Oakridge lot 6 - hoo landscape plan : scale 1/8" = 1'-0"

EcoViews: Drainage Plan

EcoViews: Hardscape Plan

EcoViews: Landscape Plan

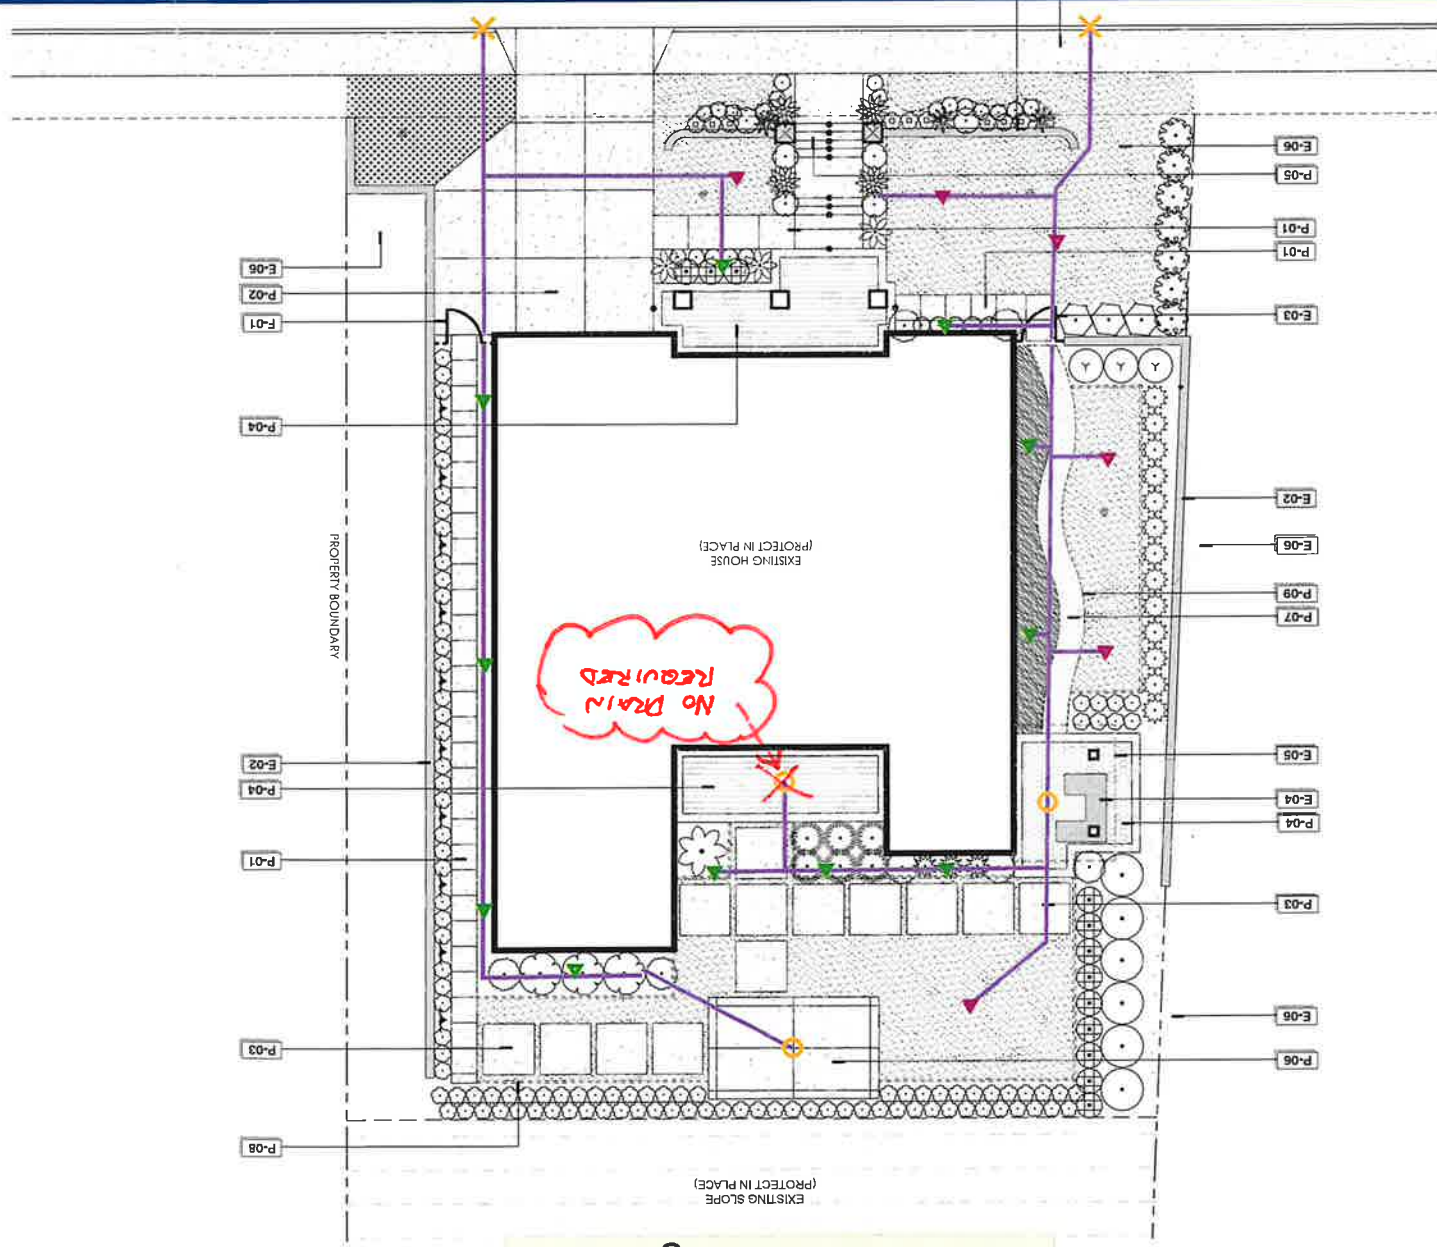
SEE REDLINE COMMENTS

EcoViews: Irrigation Plan

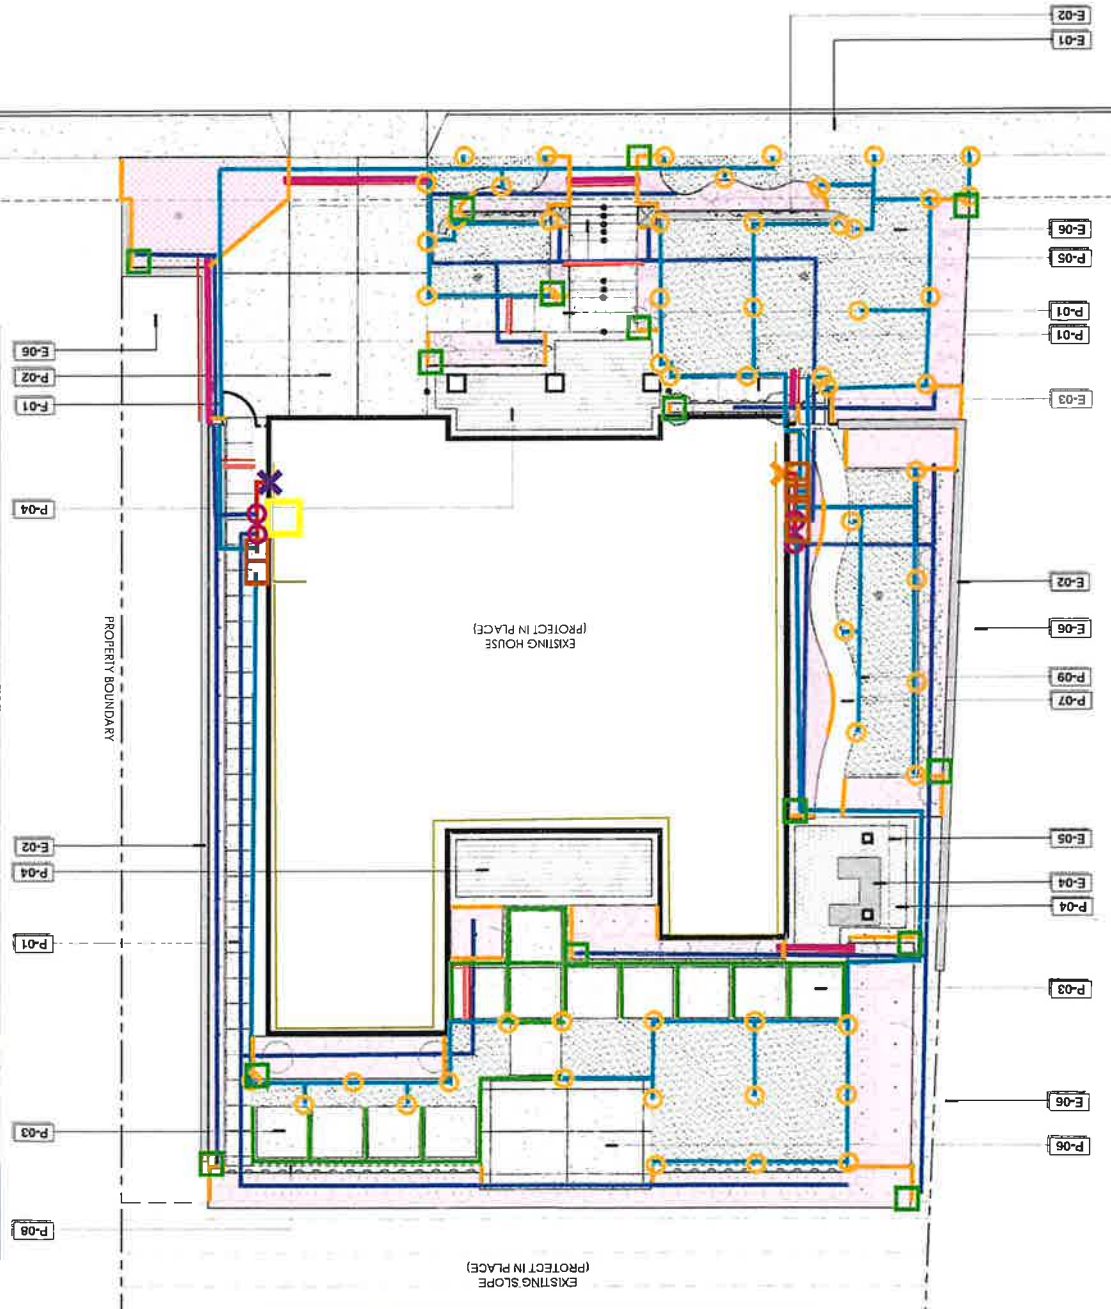
OK

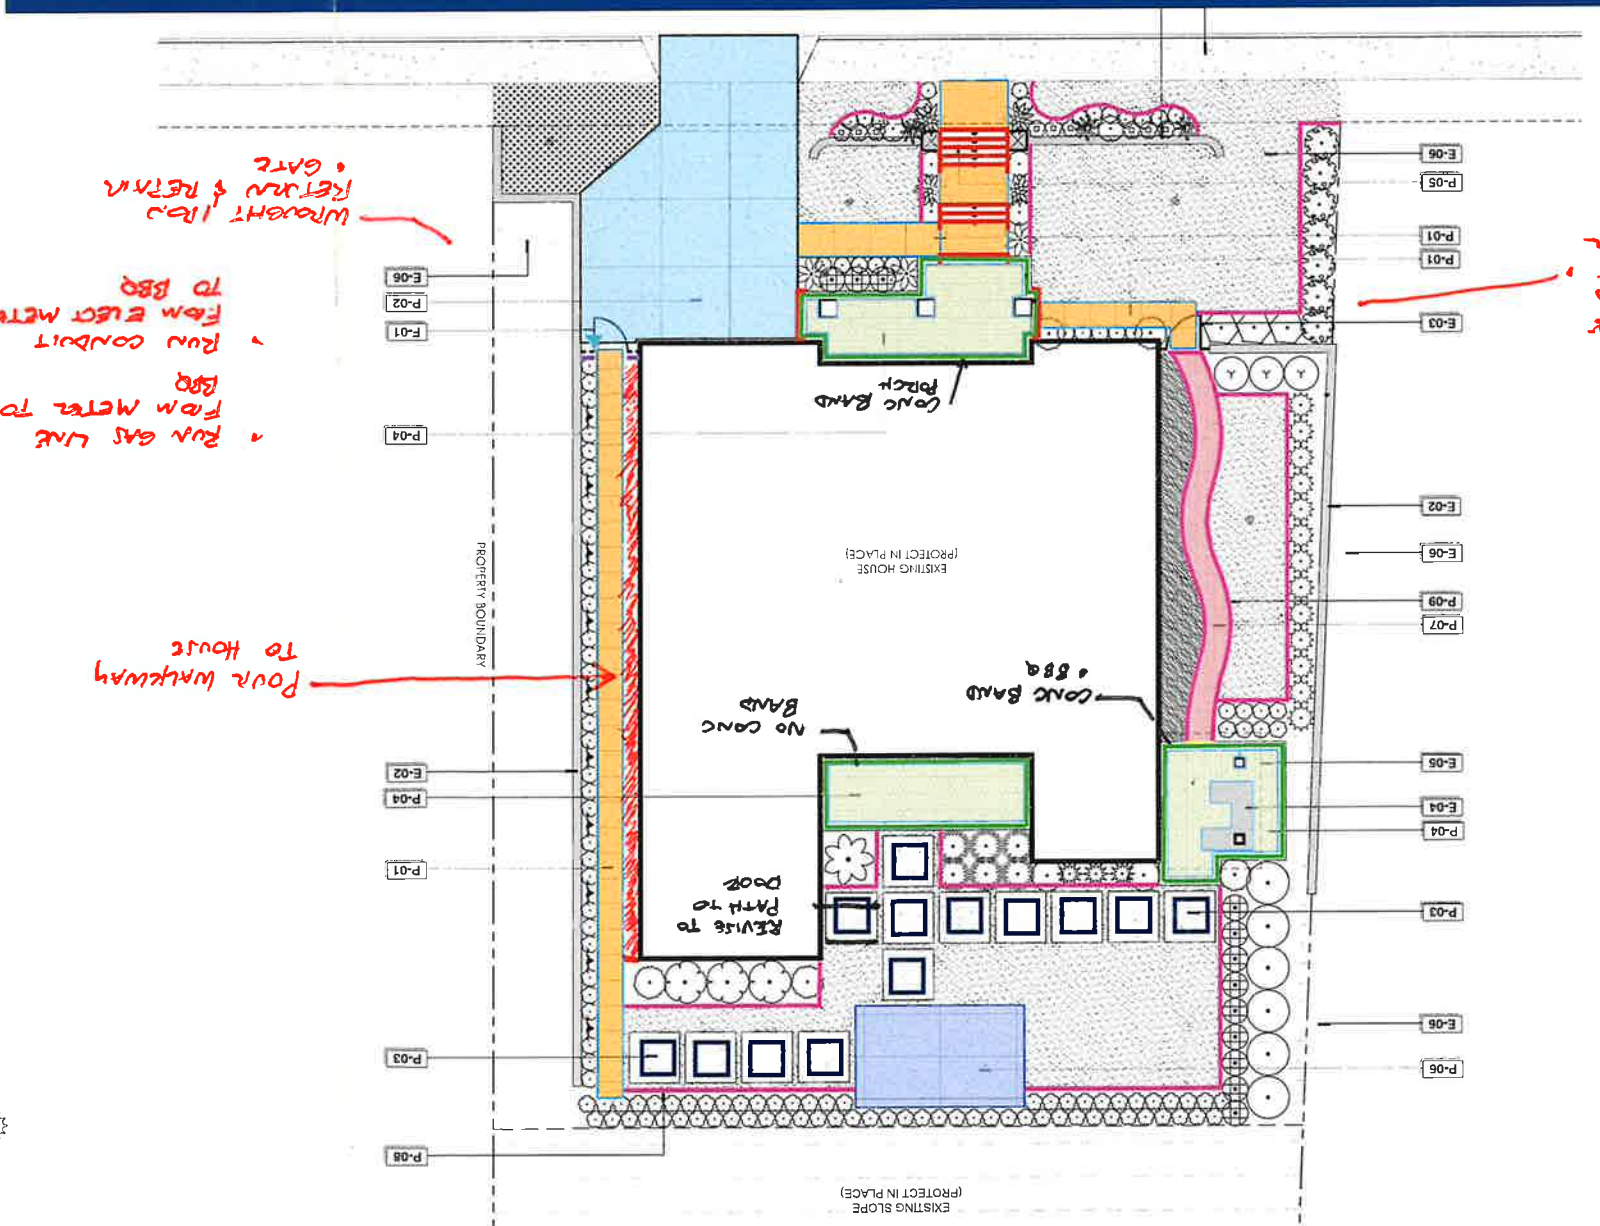
SEE REDLINE COMMENTS
